**The following is the staff report from February 17, 2021
with noted revisions (*) and prior meeting minutes attached**

BAR 20-11-03

602-616 West Main (612 West Main), TMP 290003000

Project: New, mixed-use building

NORTH ELEVATION

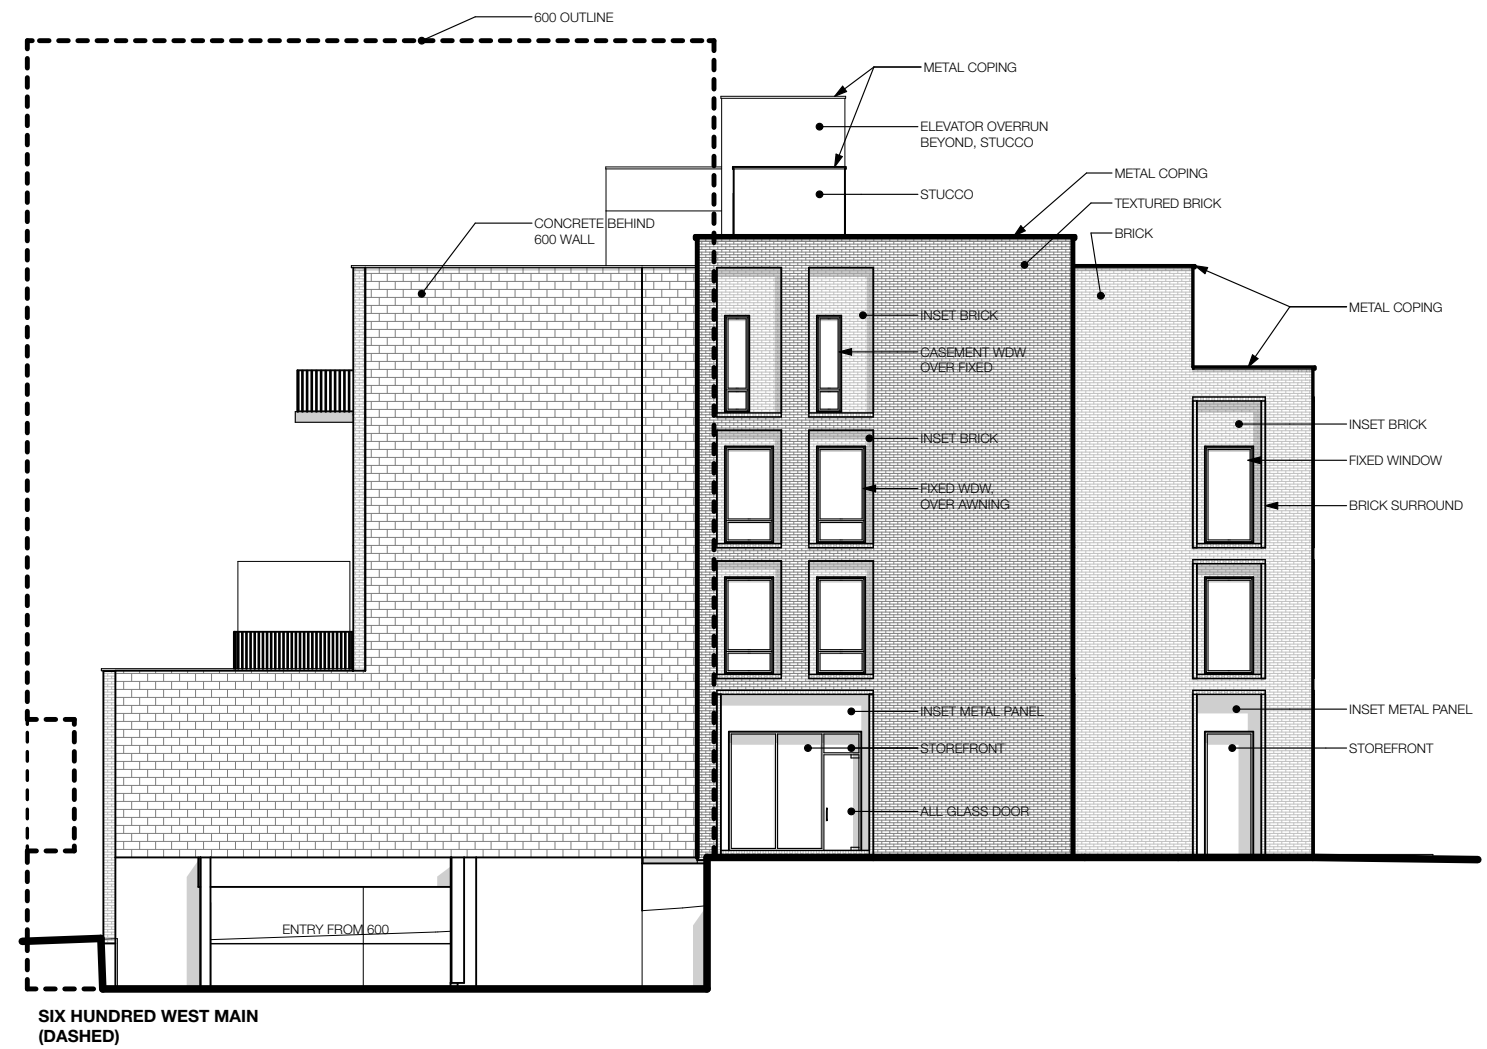
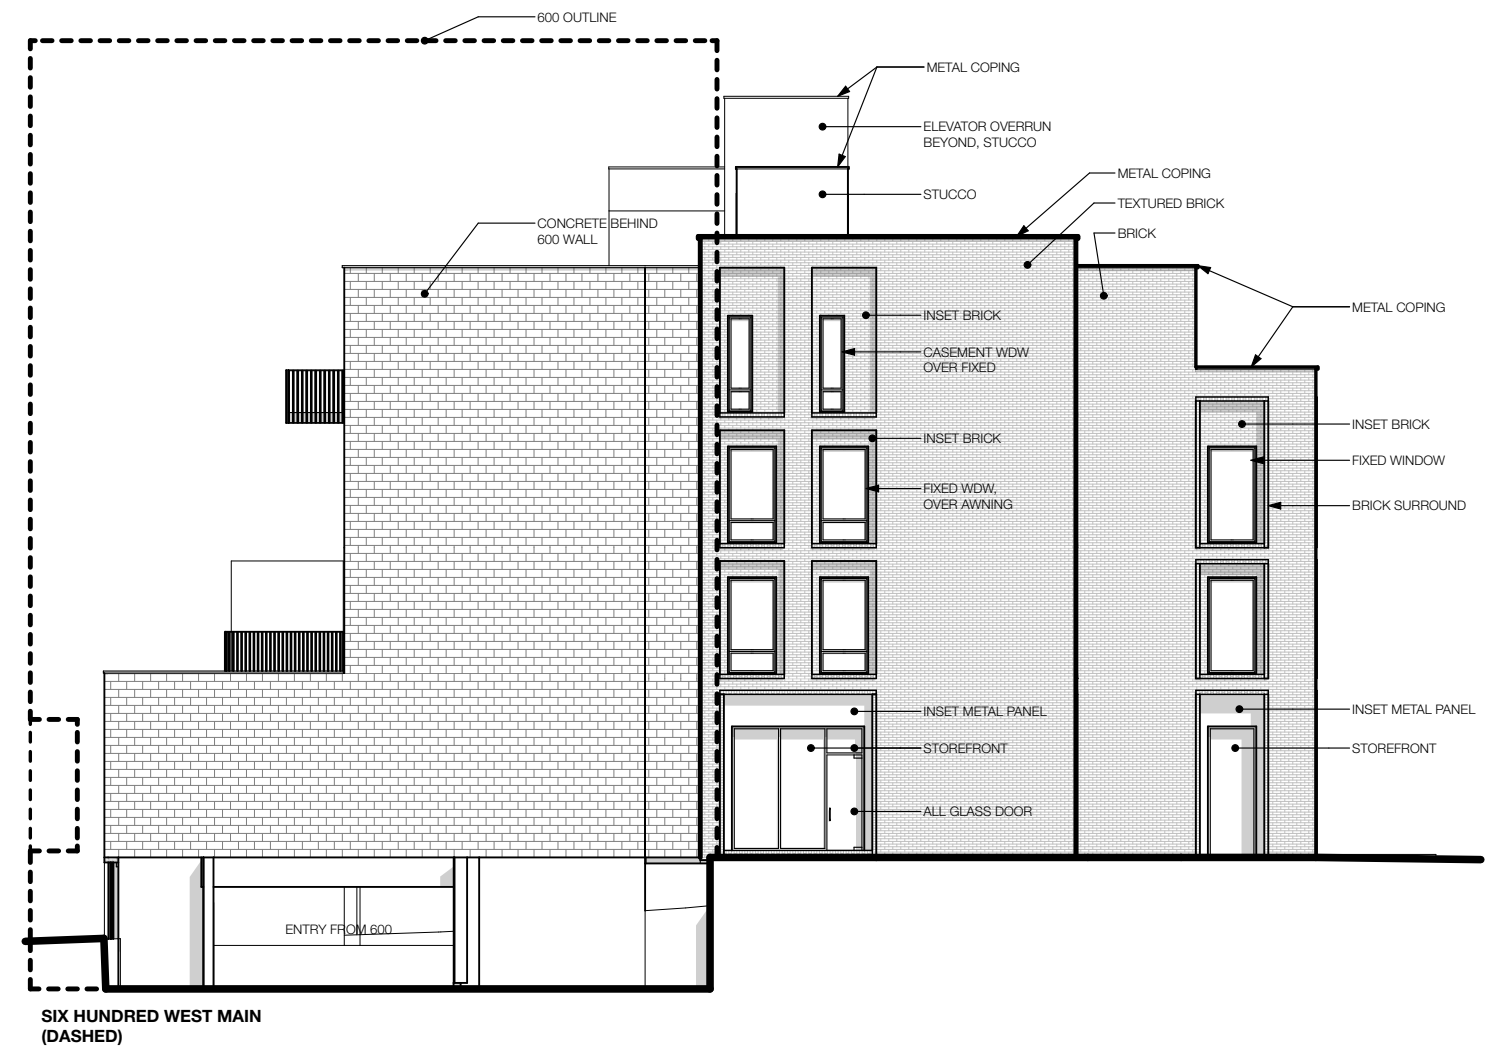
Mr. Lahendro – I would like to talk about the North elevation. This looks better to me than what I'm hearing than what's actually meant. The recessed planes of the hyphens are darker and obviously more recessed. The darkness is a symbol to indicate some kind of texture. What I'm hearing is that the texture that's desired at this point is subtle and not distinctive. I would prefer to see something that's more distinctive in the difference. I think this reads as we had intended or we had stated all along in that we're trying to mimic the scale of the individual historic buildings that are still left on this part of West Main that were here originally. That's my biggest worry about this elevation.

Mr. Gaster – I am a little concerned about the subtlety and the thinness of the plane of the North elevation. It's not so much the elevation but more that the plan and the perspective views that would come from it. I'm concerned because I think almost every view from a pedestrian point of view or for driving down the road that this is really going to look like a long building because the plan changes are so subtle. As mentioned in the last meeting, the addition of those balcony railings stepping that height down the introduction of some different texture are some good techniques. It's really riding on that line of whether this is meeting that SUP recommendation that the mass is breaking down. It might be useful to include some more oblique perspectives in the package in the future. I think that's how this building will most likely be seen. If the intention is to truly have the brick in the textured brick berry so similar in color, I wonder if a more radical technique like making one of the bays that textured brick might be worth considering. I just continue to look for more depth from the façade. I am just worried that it's getting keeps getting thinner and thinner.

LANDSCAPE PLAN
612 WEST MAIN STREET

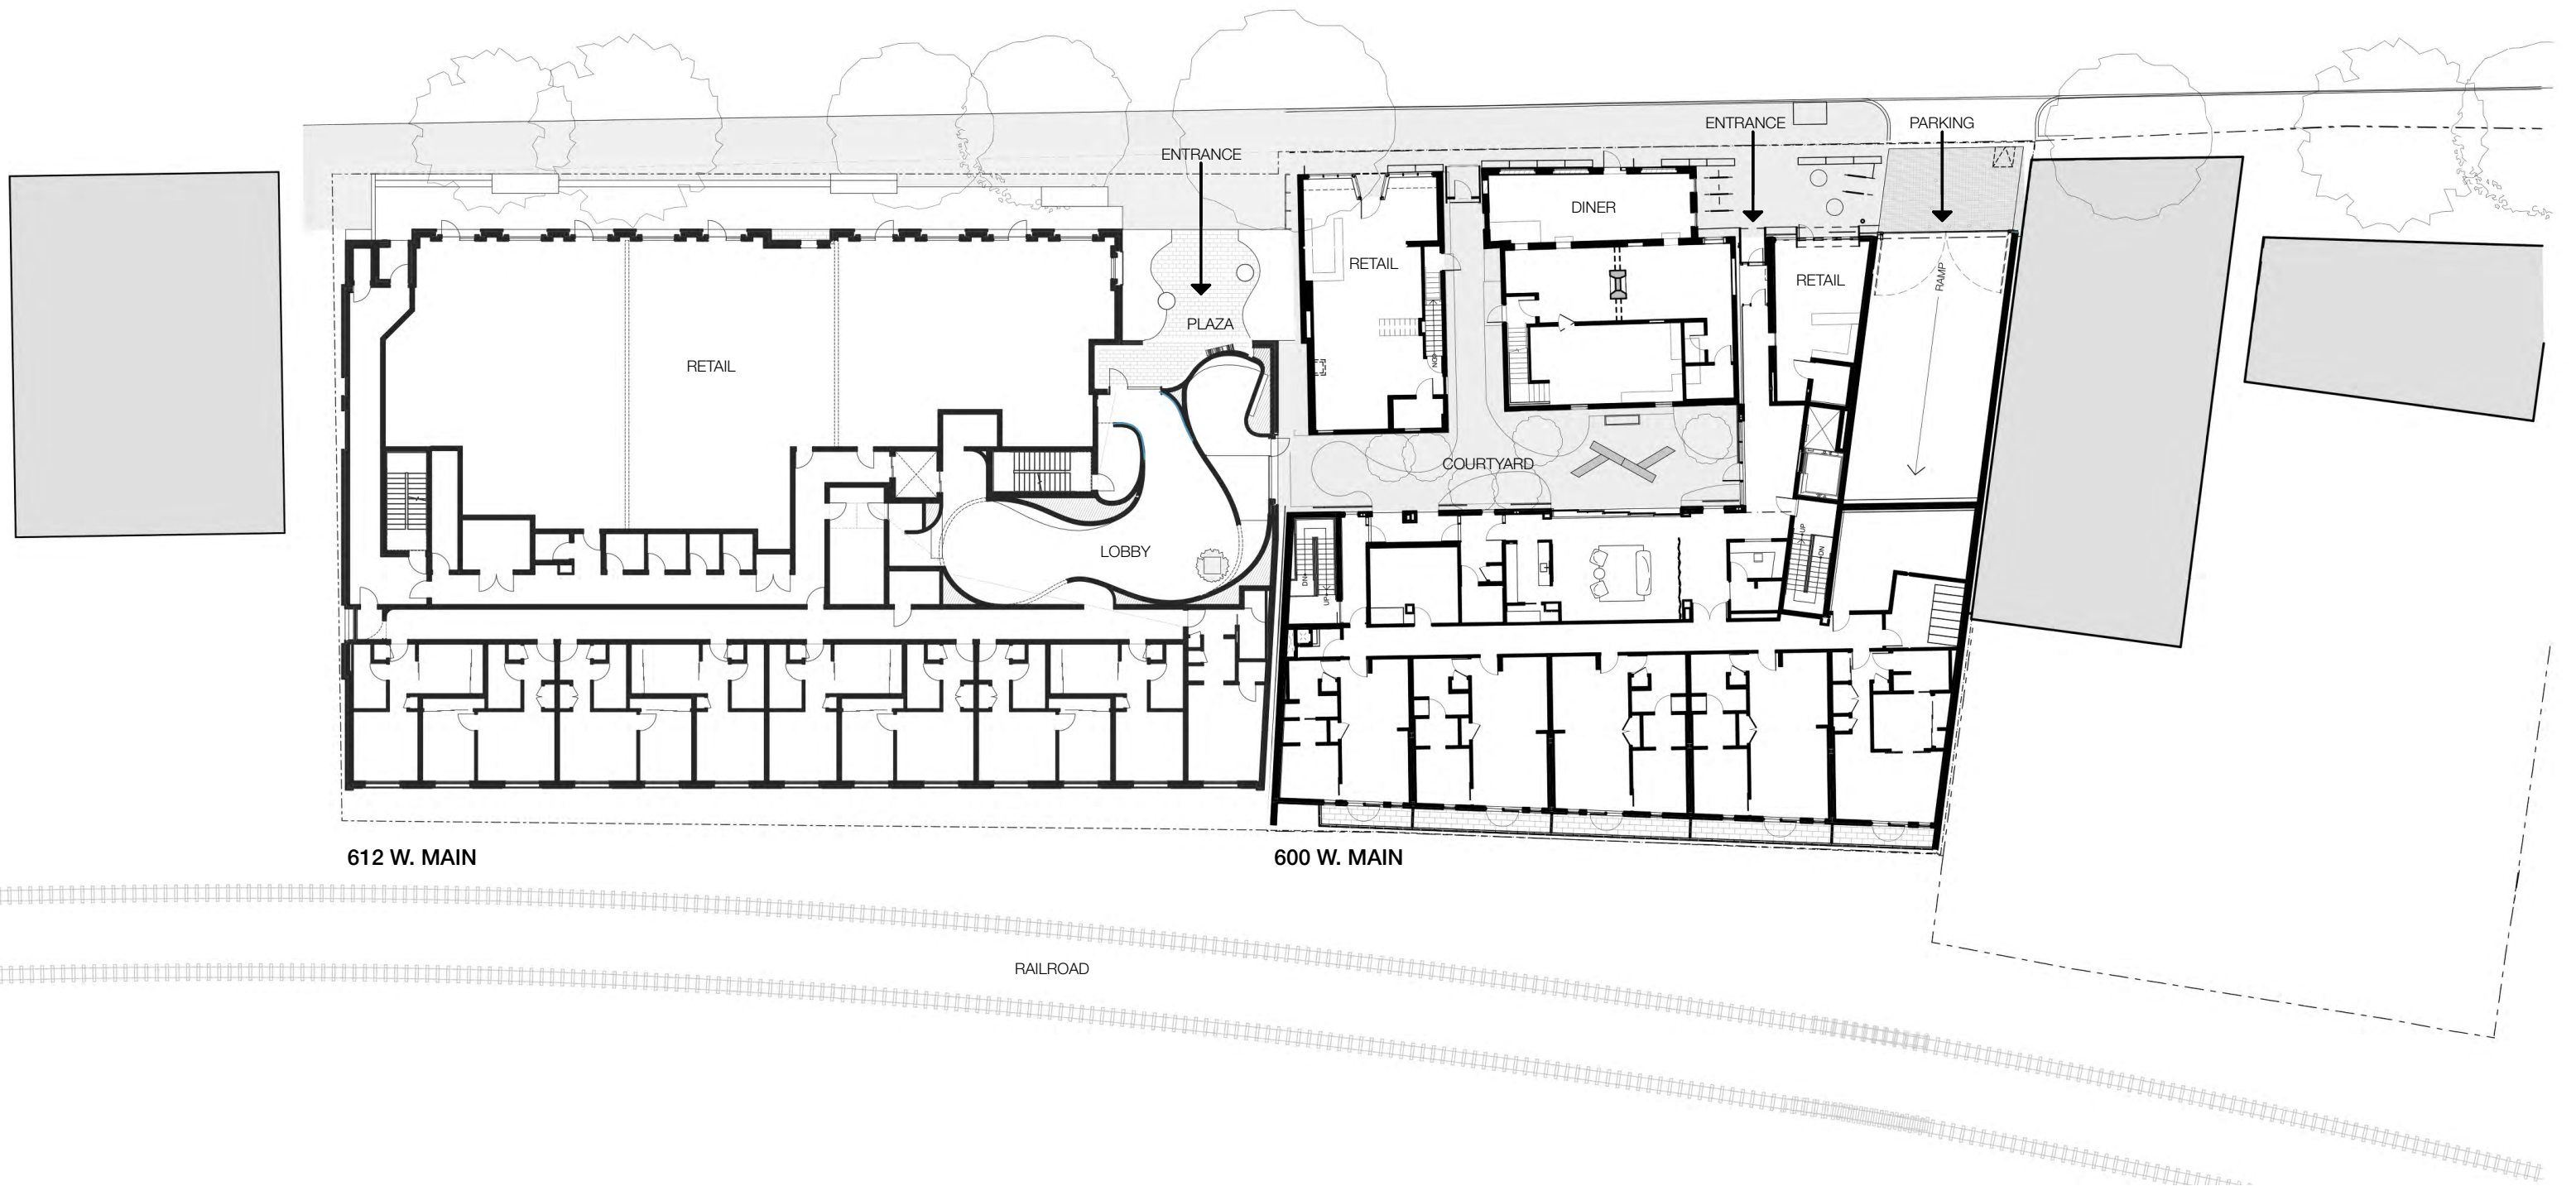
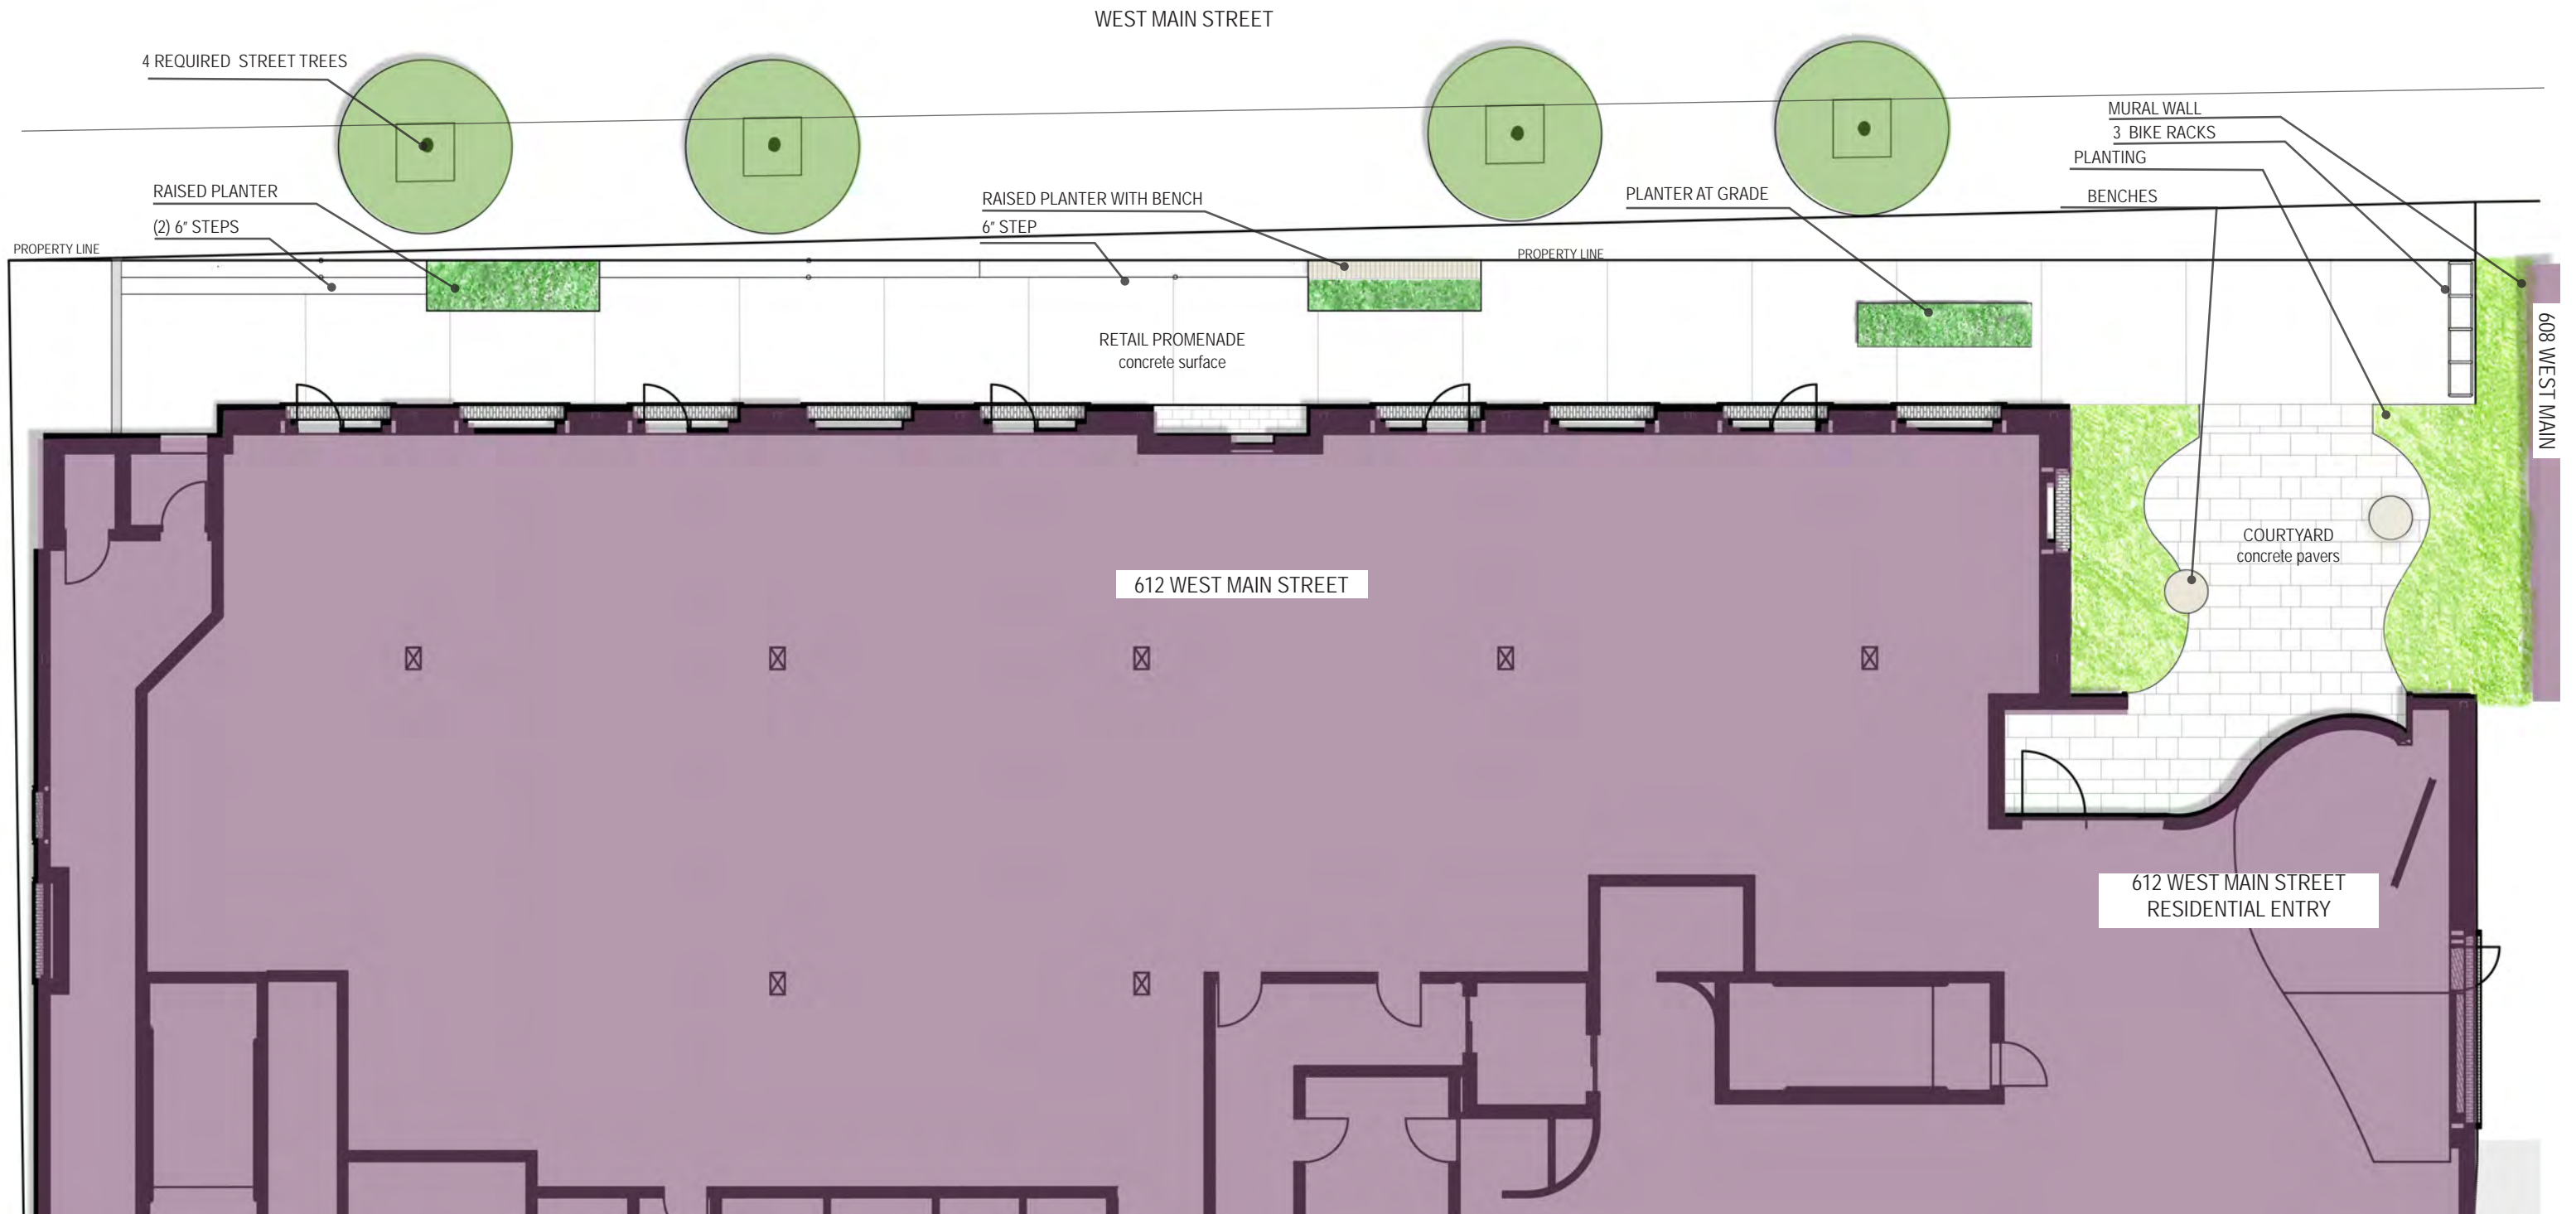
Mr. Lahendro – With the footprint for the planters, I am trying to understand the significance of this unusual truncated circle shape. It has some relevance to what is going on inside the building.

Mr. Gastinger – I really like the development of the site plan and the landscape, especially compared to where it was previously. The planters really felt like they were armoring the building or maybe having a very distinct zonation between the public sidewalk and in the walk in front of the retail spaces. I like the way that low step will get used a lot and will be a piece of street furniture. It would be in a more graceful way to make that delineation and make it more subtle. I like the shape of the planters for a couple of reasons. I think that it really does facilitate a lot more East/West movement along the facade of the building. At the same time gets a longer amount of planting area in proportion to the building. I will say though that I do think because maybe perhaps the thinness of the wall and the way that they're rendered in the plan, they do feel a little bit inconsequential or a little bit more like street furniture. There's maybe a balance there. I'm not sure if they either could get just a little bit larger or just beef up just a bit more to have a relationship to this building. There could be another one added. It seems like they're just a little bit sparse currently. I like that. I like the tactic. I like the materiality and the way that they be deployed. I think the material of them being a little bit more of street furniture and not feeling like a constructed built in feature might lend themselves to feeling a little bit more like almost quazi movable part of the street and maybe alleviate some of the fear that Jody might express about whether they really feel like they're a part of the public landscape. With the trees, this is my personal opinion. If we wait for the city to figure out West Main, we will still be waiting. I applaud the tactic to go ahead and put the trees in at the location that works best for this building. At a scale, that also works best for the street. I would hope that you'd consider species that will operate at that street tree scale and really create a high canopy that would make for a really excellent public space below. When the West Main Street project happens in about 30 years, they'll work around these trees. The only thing I would note about that is that we can be thinking about larger trees to make certain in the early planning that ample soil volumes are provided so that so that we really can get the kind of size and scale tree that they would appreciate there.

Mr. Mohr – I agree with Breck about the planters. I like the one with the seat in it. I could actually see just making that a standard feature for all three of them. The other thing I could see doing is that they weren't great in plan but in elevation and extending the plantable area along like the building, it seems to me you could play with the elevation of the edge where it could be like a cone slice or something like that, where it has some more dynamic role to play at a 3rd level. I know it's got plants in it. How many times a year are they not doing much? If it has a wandering edge or drives up one side where their playfulness is apparent, not just in plan but in elevation and section. I just fear for dominions behavior.

Mr. Dreyfus – On the interior of the building, the lobby is actually going to be a very curvilinear series of planes with few hard angles. We're trying to bring that into the residential hallways as a part of the design. Anne's thought is that we hint at it on the exterior in terms of the planter shape with what is happening on the interior.

Ms. Pray – That was definitely a starting point. We liked the idea that the planters became more sculptural as part of the experience being on the sidewalk. The space between them still feels like inside.
